**MEMORANDUM**

**REVIEW TYPE:** Site Plan Review  
**APPLYING FOR:** 266,146 square feet, including 180 residential housing units, plus optional retail mezzanine space of 6,194 square feet

**PROJECT NAME:** Arlington East  
**CASE #:** Site Plan #8-02035 with Preliminary Plan 1-99088  
**REVIEW BASIS:** 59-D-3, Site Plan and 59-C-4.351

REVISED LAY-BY STUDY, ARLINGTON EAST  
 FEDERAL REALTY INVESTMENT TRUST  
 TERRY GAULDS AND PARTNERS, CHP 9.19.02

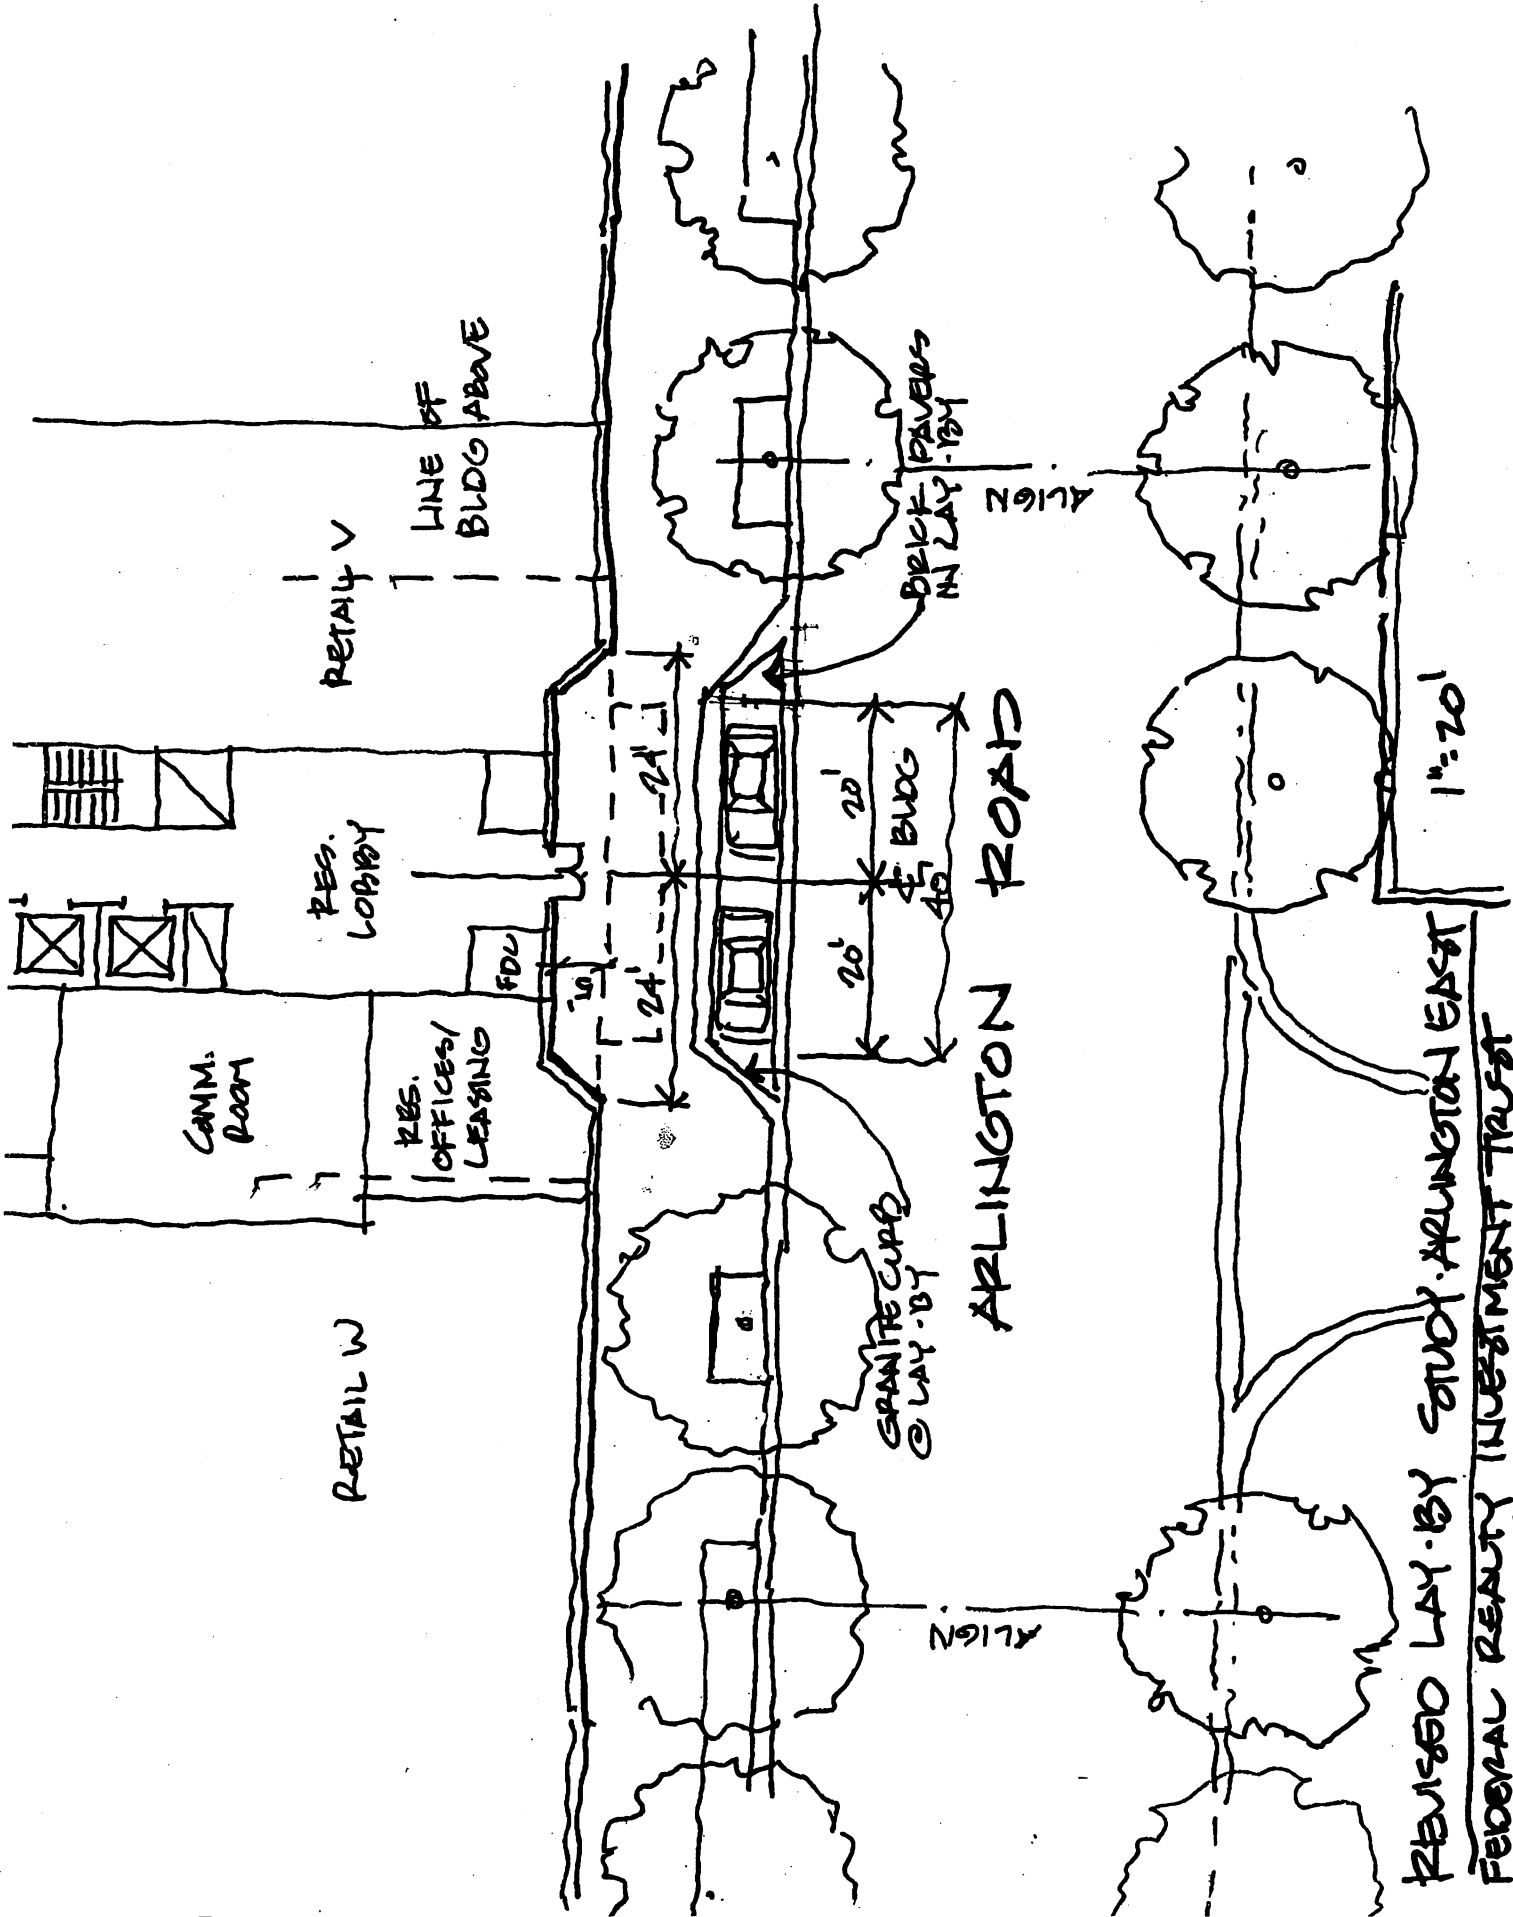
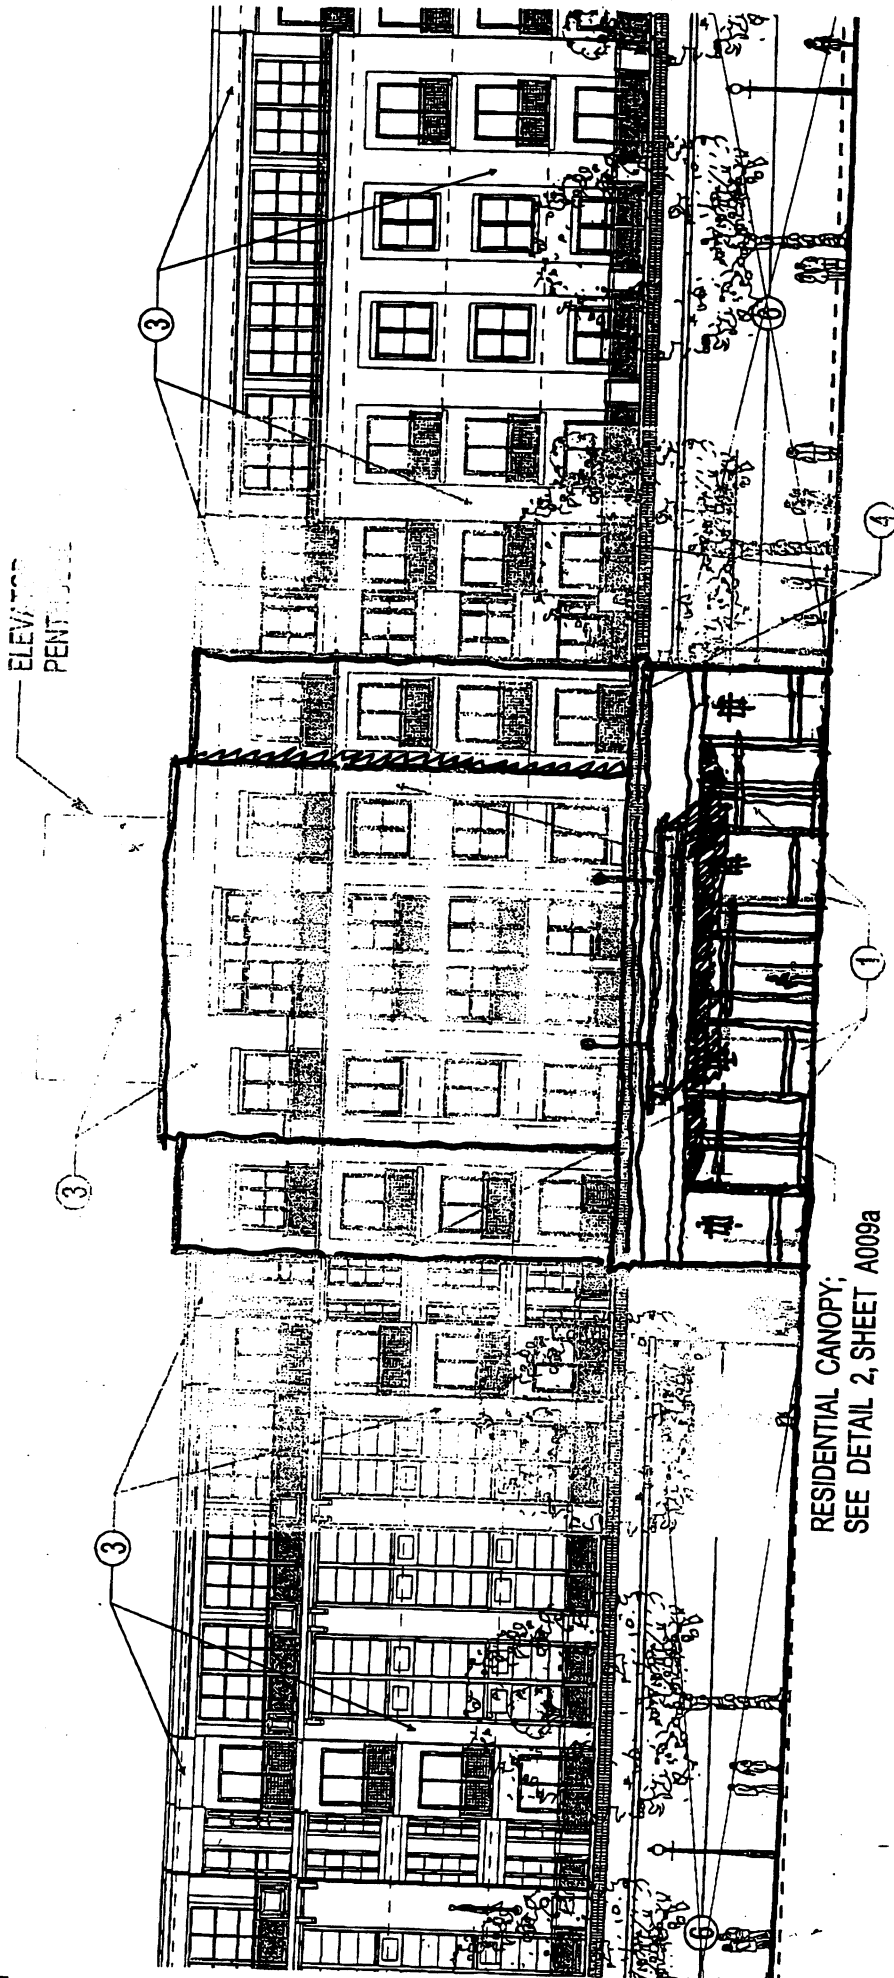
The applicant proposes a vehicular drop off at the residential building entrance along Arlington Road. Staff regards such features in the public realm with great concern for their intrinsic intrusion on pedestrian movement and safety, interference with public space within the right-of-way, discouragement of the use of alternate forms of transportation, and the obvious conflict with the pedestrian-predominant character of the Bethesda CBD.

However, in view of the applicant's statement of necessity and the financial viability of the project, staff views the allowance of the drop off with the following limitations: smallest feasible dimensions (40 feet in length), brick paving for the entire drop off area, granite curbing, and the recess of the building façade for the entire length of the drop off. These conditions will allow a full 15-foot sidewalk passage at the building entrance and one additional street tree on the Arlington Road frontage. The applicant has submitted a sketch for the revised design (see attachment).

Although staff carries serious reservations about the vehicular drop off on Arlington Road, the dimensions and streetscape treatment have been designed to minimize the impact on pedestrians to a reasonable extent. [See sketch attached for the revised design of the vehicular drop off.]

- b. Reduce the length of the drop-off to 40 feet;
  - c. Add an additional street tree at the north end of the drop off, with tapered tree grate fitted within the curb flare; provide matching tree grate for the street tree at the south end of the drop off;
